Date: August 1, 2007
To: T10 Technical Committee
From: Alvin Cox (alvin.cox@seagate.com)
Subject: SAS-2 6Gbps PHY Electrical Specification

Abstract: The attached information defines the electrical requirements for 6 Gbps transmitter devices and receiver device. In addition, updates include reference transmitter and receiver device definitions to provide a means of determining if a channel is compliant and a cable specification section with requirements for 6Gbps usage. This proposal is a continuation of 07-063, at it ran out of revisions available.

Revision History:

r0: Initial posting that has changes documented up to but not including section 5.3.6.5.

Figure aa Transmitter device common mode voltage limit

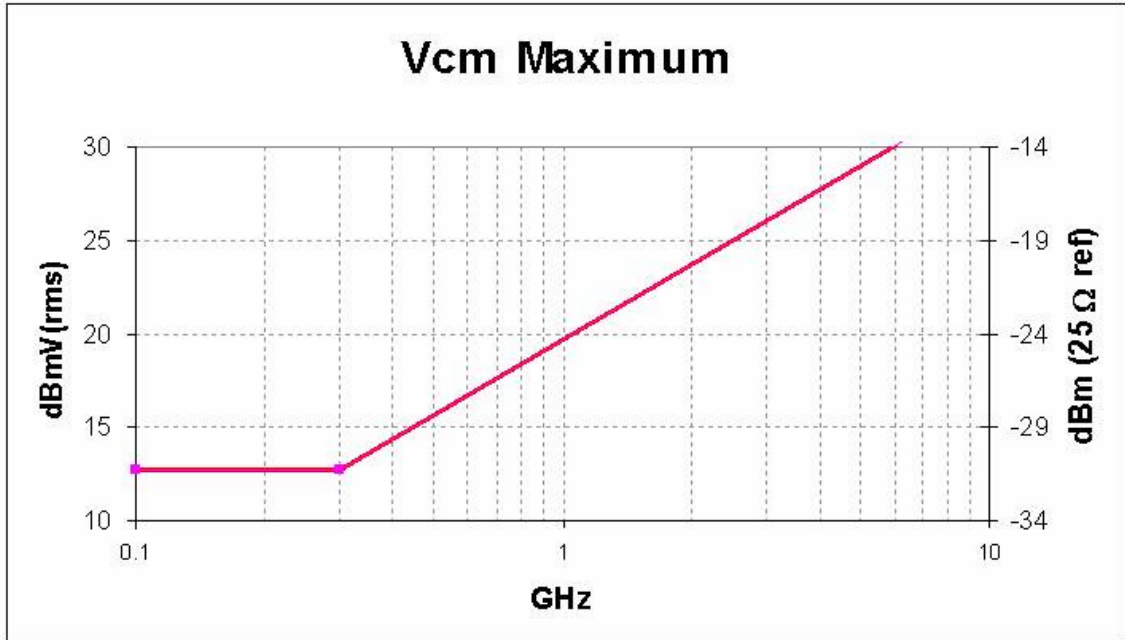
Signal characteristic	Units	Min	Nominal	Max
Peak to peak voltage (i.e., 2 x Z ₂ in figure 114) if SATA is not supported ^a	mV(p-p)	800		1200
Transmitter device off voltage ^b	mV(p-p)			50
Minimum rise/fall time ^c	UI (ps)	0,25 (41,667)		
OOB offset delta ^d	mV			±25
OOB common mode delta ^e	mV			±50
Reference Diff Impedance	Ohm		100	
Reference Common Mode Impedance	Ohm		25	
Common mode voltage limit (rms) ^f	dBmV ^g			26
Random Jitter (0101b pattern, zero-length test load) ^h	UI (ps)			0,15 (25)
Total Jitter (thru ref channel, ref receiver, CJTPAT) ⁱ	UI (ps)			0,60 (100)
Differential eye opening (pk-pk) V _{pk-pk} (thru ref channel, ref receiver, CJTPAT) ⁱ	mV	tdb

a See 5.xxx for measurement method. Value is measured as V_{pk-pk}.
 b The transmitter device off voltage is the maximum A.C. voltage measured at compliance points IT and CT when the transmitter is unpowered or transmitting D.C. idle (e.g., during idle time of an OOB signal).
 c Rise/fall times are measured from 20% to 80% of the transition with a repeating 0101b pattern (see table 214 in 10.2.9.1) on the physical link.
 d The maximum difference in the average differential voltage (D.C. offset) component between the burst times and the idle times of an OOB signal.
 e The maximum difference in the average of the common-mode voltage between the burst times and the idle times of an OOB signal.
 f Maximum value at the Nyquist frequency (3 GHz). See figure aa.
 g For dBmV, the reference level of 0 dBmV is 1 mV. Hence, 0 dBm is 1 mW which is 158 mV across 25 ohms (the reference impedance for common mode voltage) which is 20log10(158) = +44 dBmV. +26 dBmV is, therefore, -18 dBm.

Figure xxw Return loss variables

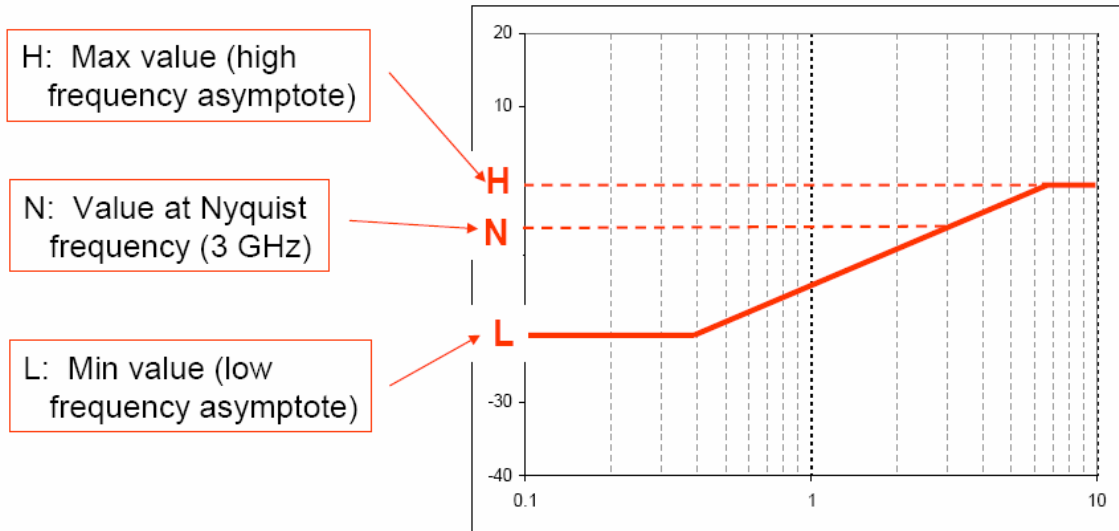
Return loss limits shall be calculated per the following formula. Variables are illustrated in Figure xxw and specified in Table 2.

$$\text{Measured Value} < \max [L, \min [H, N + 13.3 \log_{10}(F/3\text{GHz})]]$$

Figure xxy Transmitter Differential and Common Mode Return Loss

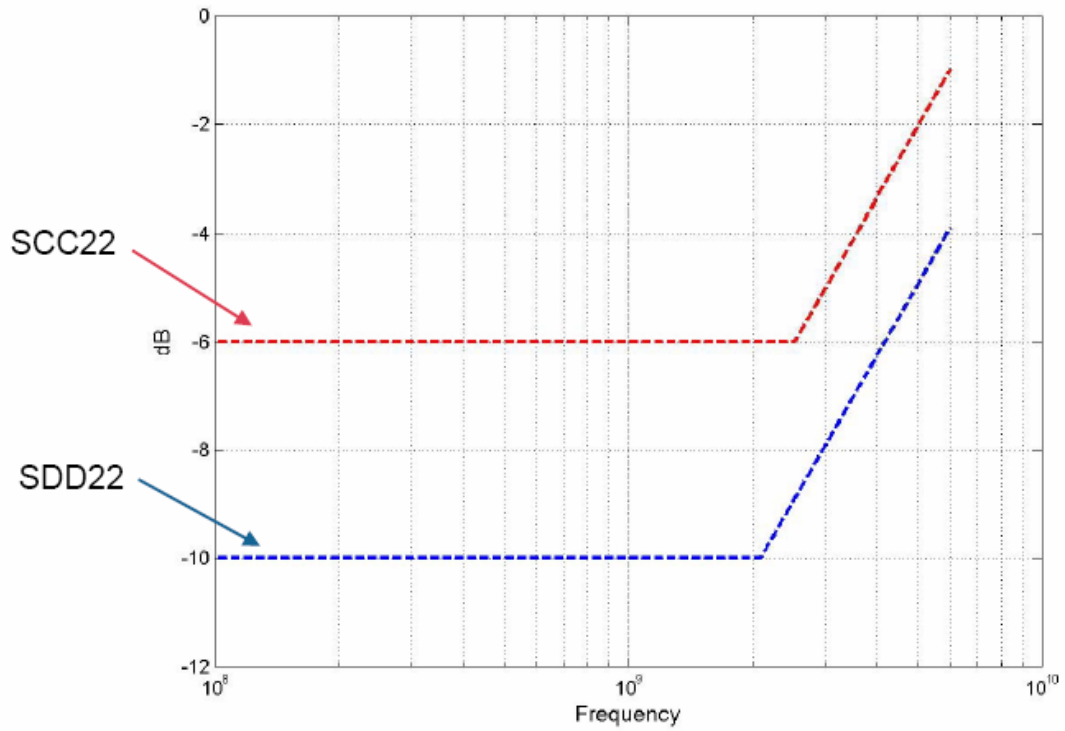
Figure	L(dB)	N(dB)	H(dB)	S(dB)	F _{Min} (MHz)	F _{Max} (GHz)
SCC22 common mode return loss	xyy	-6,0	-5,0	0	13,3	100	6,0
SDD22 differential return loss	xyy	-10	-7,9	0	13,3	100	6,0
SCD22 differential to common mode conversion	xxz	-26	-12,7	-10	13,3	100	6,0

1. For return loss measurements, the transmitter under test shall transmit a continuous D24.3 pattern. The amplitude shall be -4,4 dBm (190mV zero to peak) maximum per port. See section B.9.3.
2. The return loss numbers indicate the value on the transmitter side of the compliance point connector rather than at the compliance point (i.e., IT or CT)

Figure xxx Transmitter equalization measurement

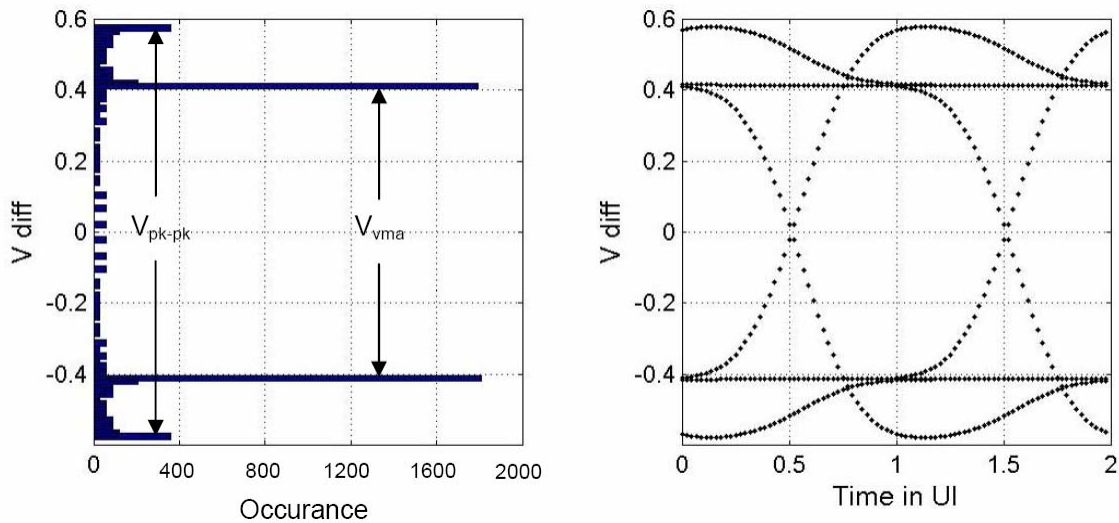
- c. The V_{vma} mode value and V_{pk-pk} peak value shall be determined as illustrated in Figure xxx. A sample size of 1000 minimum, 2000 maximum histogram hits for V_{vma} shall be used to determine the values. The histogram in the figure is a combination of two histograms, an upper histogram for TX+ and lower histogram for TX-. (The histograms on the left of the test pattern signal displayed on the right.) The V_{vma} mode value and V_{pk-pk} peak value are determined by adding the values measured for TX+ and TX-.

- d The following formula shall be used to calculate the equalization value:

$$DE_{dB} = 20 \text{Log}_{10} \left(\frac{V_{pk-pk}}{V_{vma}} \right)$$

Figure xyx Receiver Differential and Common Mode Return Loss

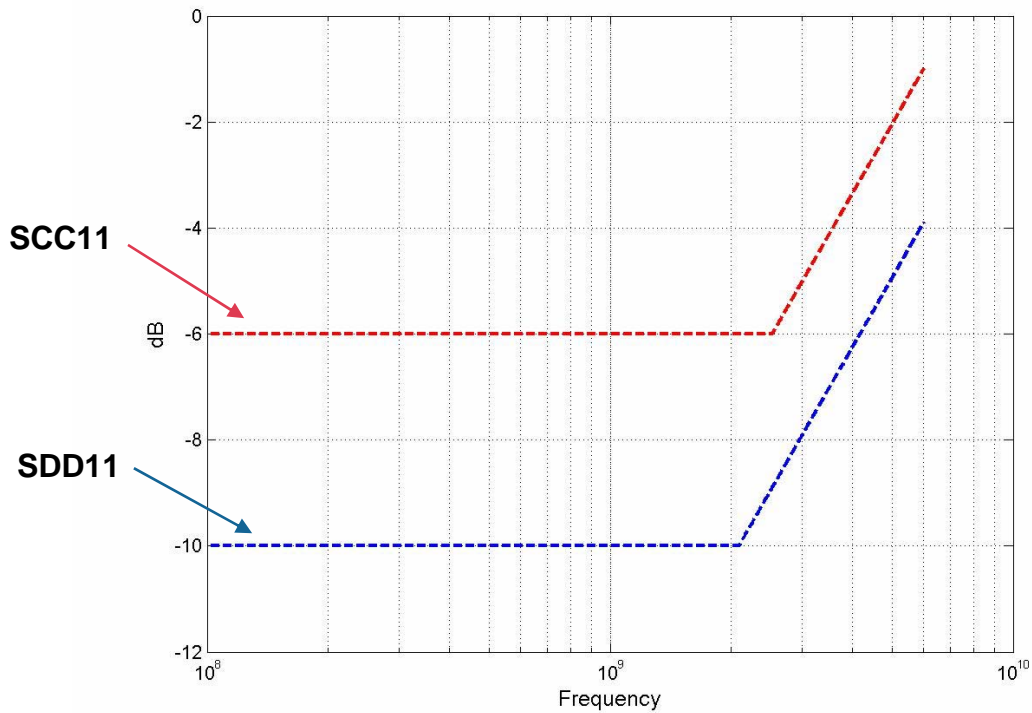
The receiver's return loss is illustrated in Figure xyx. (Need pointer to reference termination file.) The reference receiver has a 3 tap DFE with infinite precision taps and unit interval tap spacing. The reference coefficient adaptation algorithm is the Least Mean Squared (LMS). The DFE equalizer can be modeled at the center of the eye as:

Return loss limits shall be calculated per the following formula. Variables are illustrated in Figure xxw and specified in Table 5.

Figure	L(dB)	N(dB)	H(dB)	S(dB)	F _{Min} (MHz)	F _{Max} (GHz)
SCC11 common mode return loss	xyx	-6,0	-5,0	0	13,3	100	6,0
SDD11 differential return loss	xyx	-10	-7,9	0	13,3	100	6,0
SCD11 differential to common mode conversion	xyy	-26	-12,7	-10	13,3	100	6,0
Notes:							
1. For return loss measurements, the transmitter shall transmit a continuous D24.3 pattern. The amplitude shall be -4,4 dBm (190mV zero to peak) maximum per port. See section B.9.3.
